VILLAGE OF DOWNERS GROVE Report for the Village 10/11/2022

SUBJECT:	SUBMITTED BY:		
7251 and 7261 Lemont Road Planned Unit Development	Stan Popovich, AICP		
Amendment	Community Development Director

Re: Response Letter to Village Council Meeting Comments
 Proposed Restaurant/Retail Project
 7251 & 7261 Lemont Rd.
 Downers Park Plaza, Proposed Lot 1-B

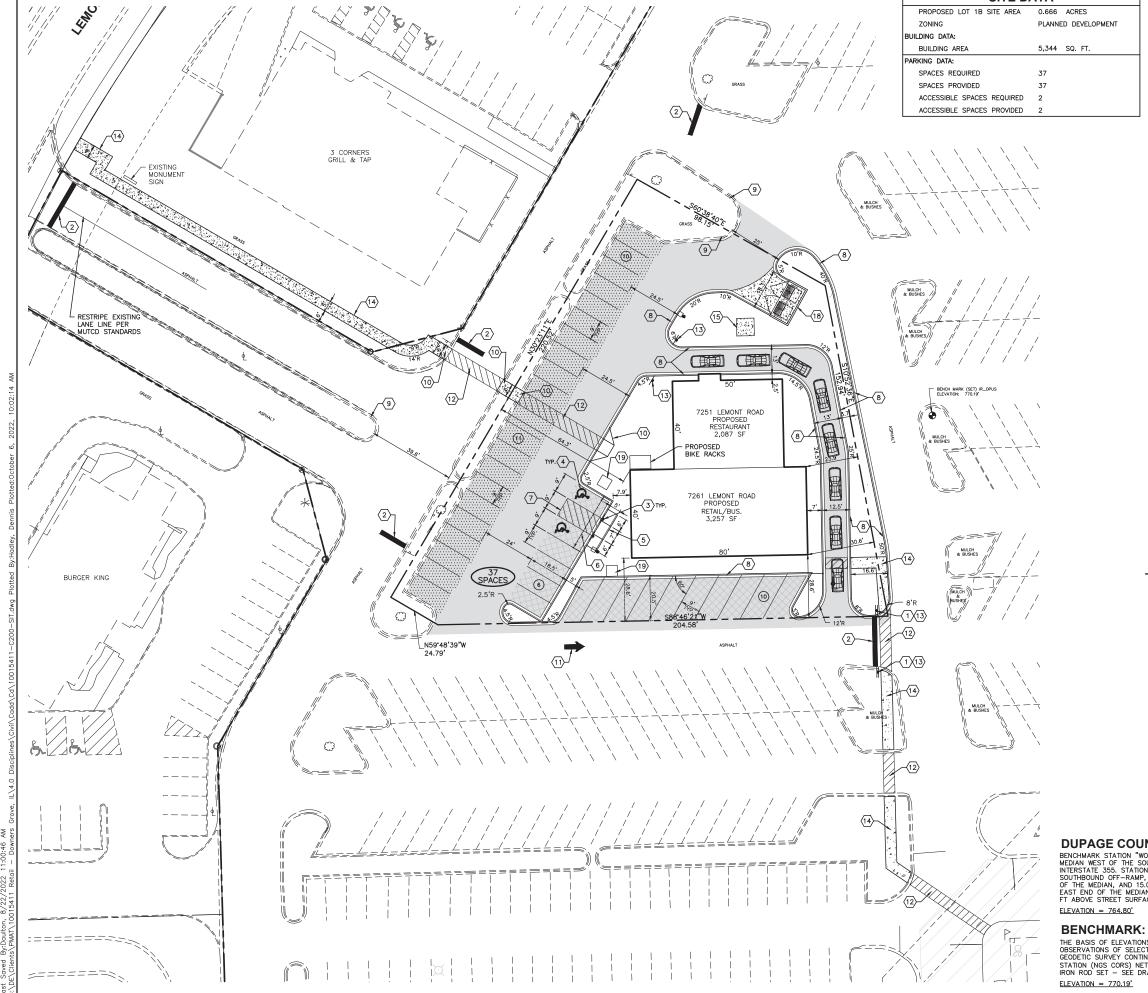
This item was discussed at the October 4, 2022 Village Council meeting. Based on Council discussion, the petitioner has made the following updates to their proposal:

1. An additional set of windows were added to the south facade.

2. An additional set of windows were added to the north facade.

3. A pedestrian connection has been added which will connect this development with the existing sidewalk system for the rest of the center. The sidewalk will run south from the proposed development site to the sidewalk in front of 7339 Lemont Road.

Enclosed are revised drawings, per discussions and comments at the Village Council meeting on October 4th, 2022, which provide additional storefront along the left (north) and right (south) elevations and proposes an additional pedestrian connection to Lot 2 as part of the proposed development of Lot 1-B.

We have provided for additional storefront at both the above referenced building elevations to the extent feasible. Any additional storefront along both elevations will begin to be placed in undesirable locations which will interfere with interior design, specifically on the north elevation where additional windows would begin to be located within the kitchen/prep area and the south elevation where additional storefront would begin to be located towards stockrooms or storage areas, along with possibly limiting merchandise placement along these walls depending on the final end user's floor planning.

An additional pedestrian crossing has been provided to the existing sidewalk at the retail building located on Lot 2. This routing was carefully considered to allow for a final connection at the fully controlled (4way stop) intersection and will allow for a full connection from Lemont Rd to Lot 2 as part of construction on this project.
